April 23, 2021

Routt County Regional Building Department

RE: SSRC – Steamboat Gondola Relocation Project (B-21-204)
ESA Project Number: 20034.00

Attached you will find the proposed Addendum to the Permit for the Steamboat Gondola Relocation Project (B-21-204). This addendum includes the following changes:

1 ELEVATOR SECTION (EW)
A302 1/4" = 1'-0"

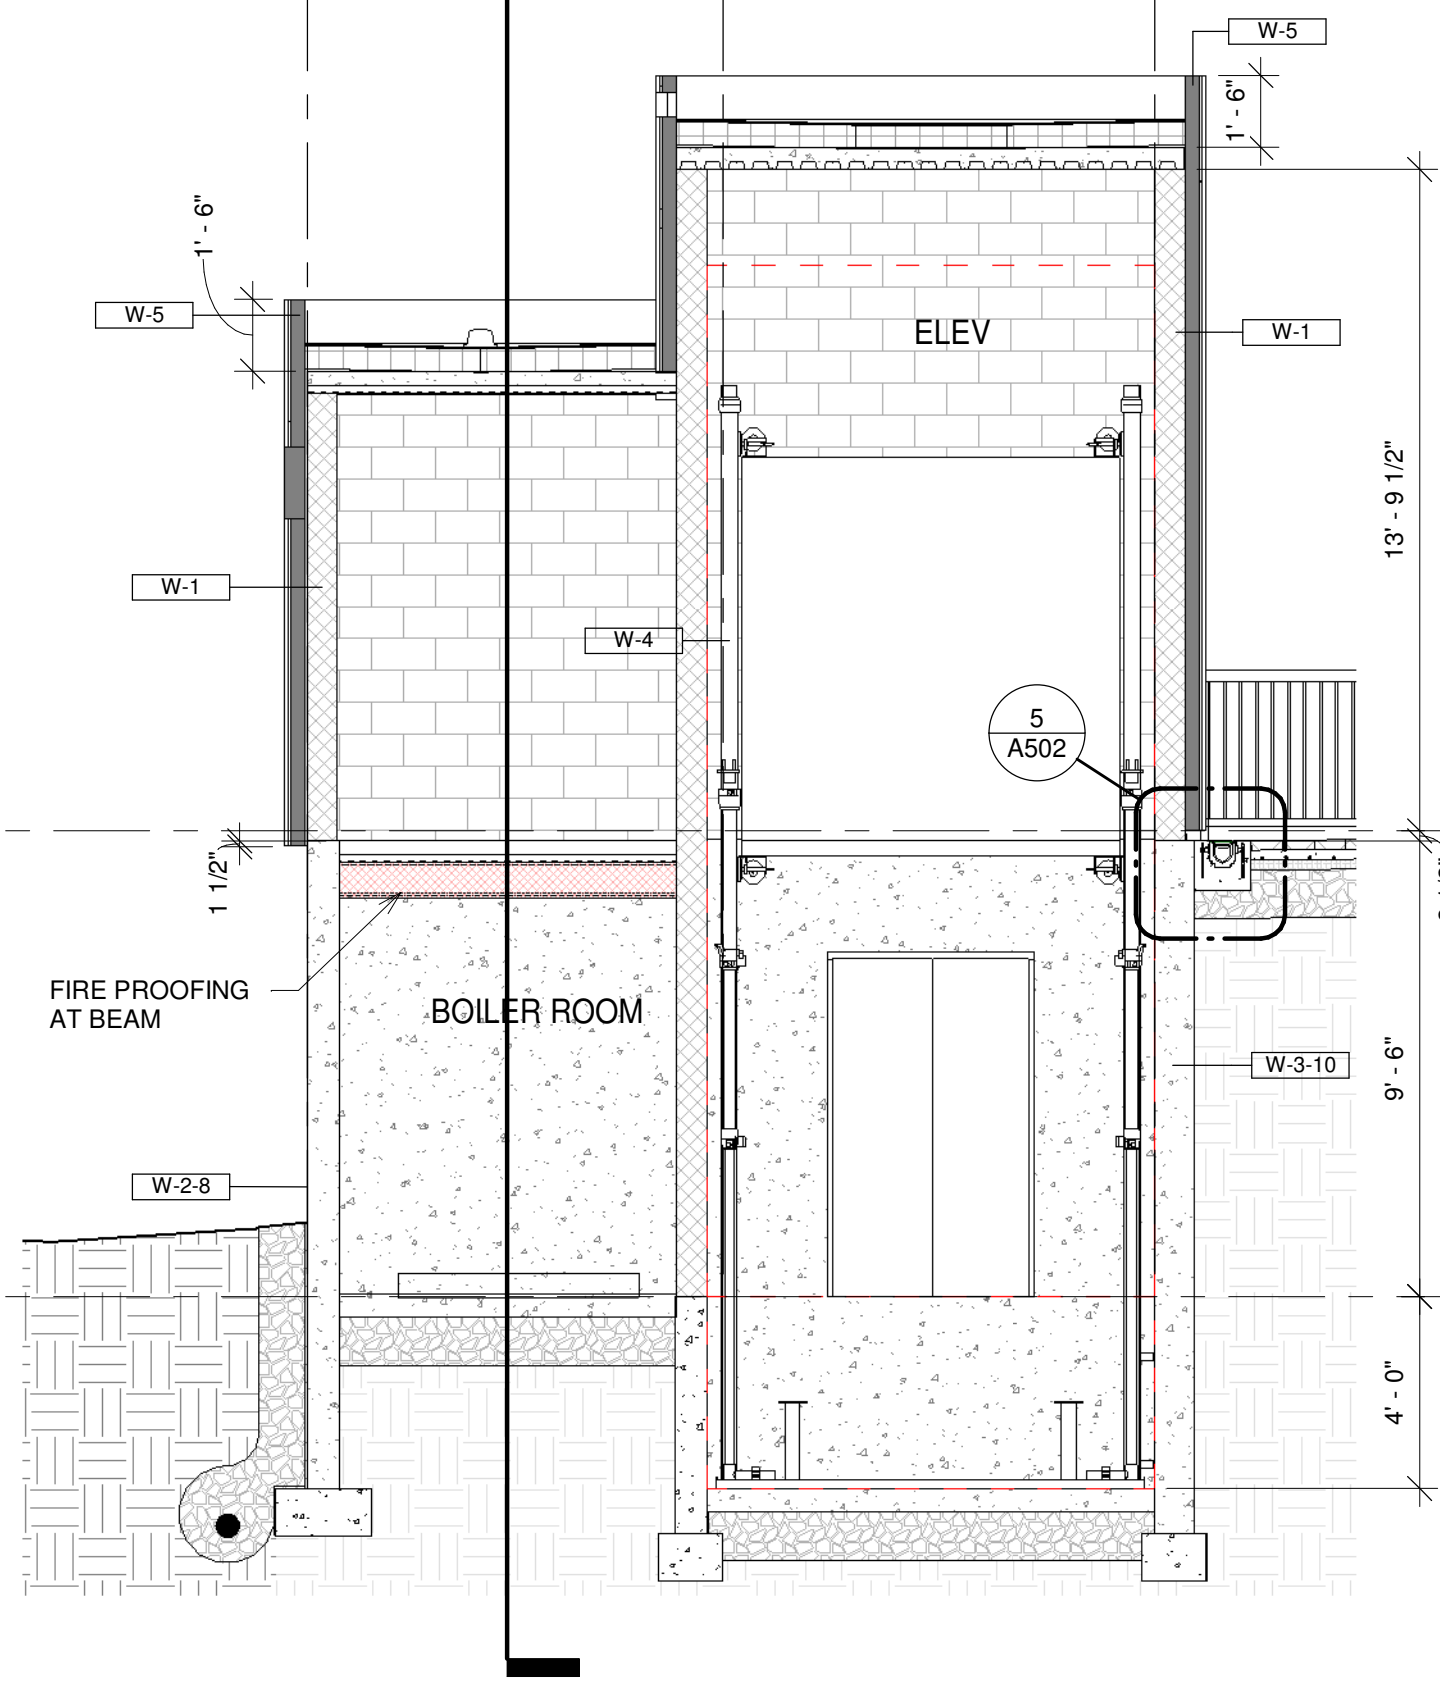
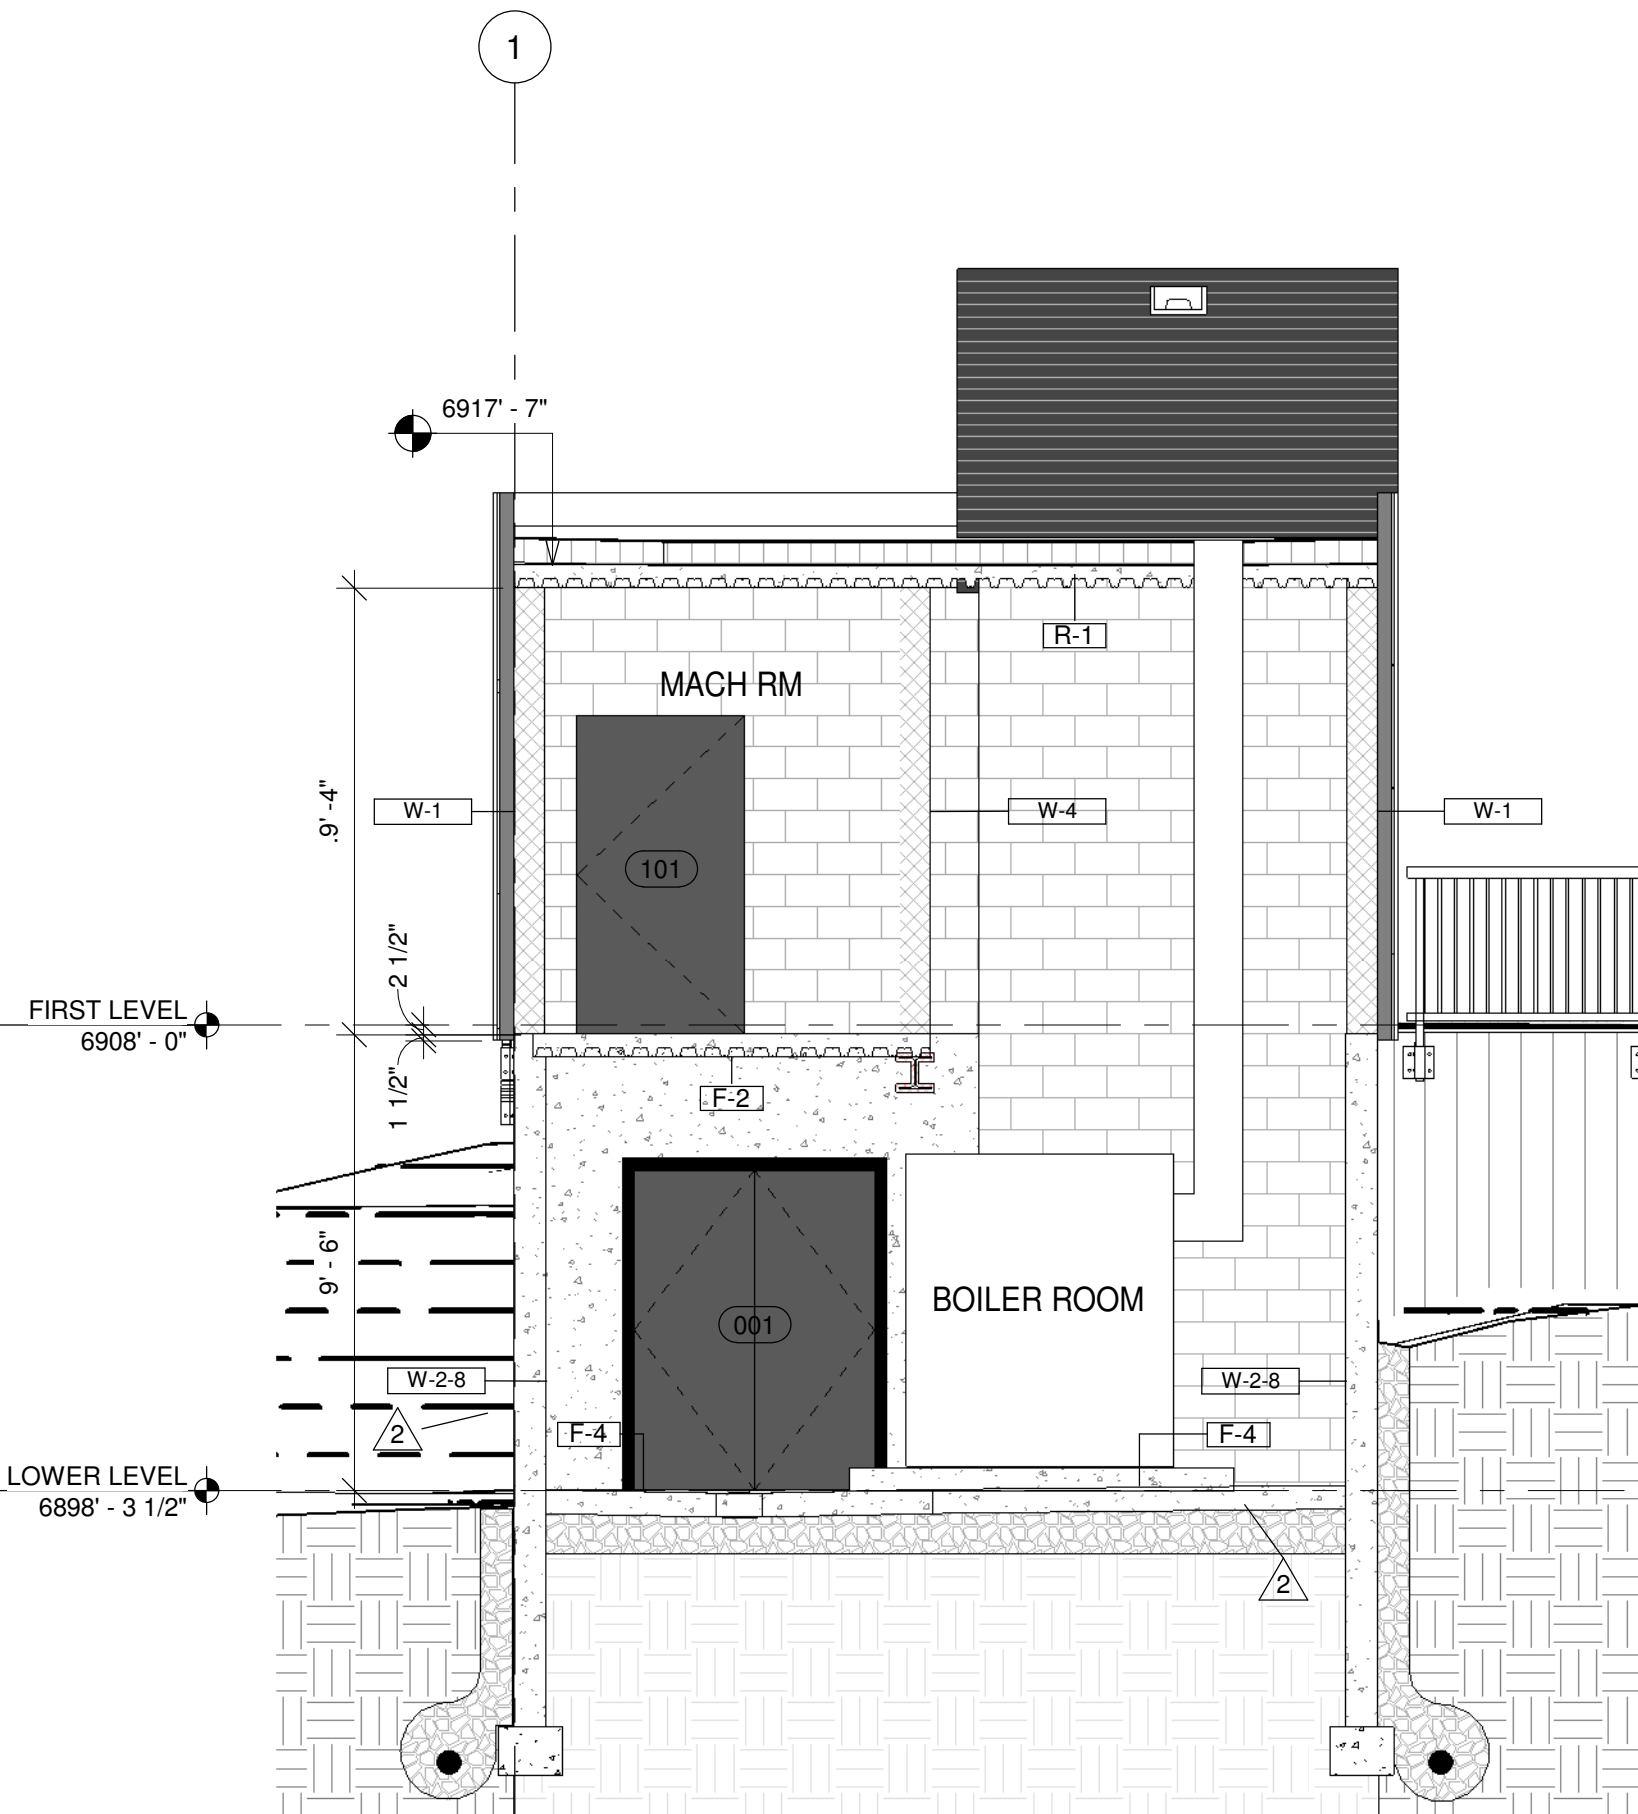
- To accommodate the freight, the elevator cab needs to be wider than originally specified. The elevator has gone from a 3500 lb to 4000 lb unit. The elevator shaft now projects into the Boiler Room slightly.
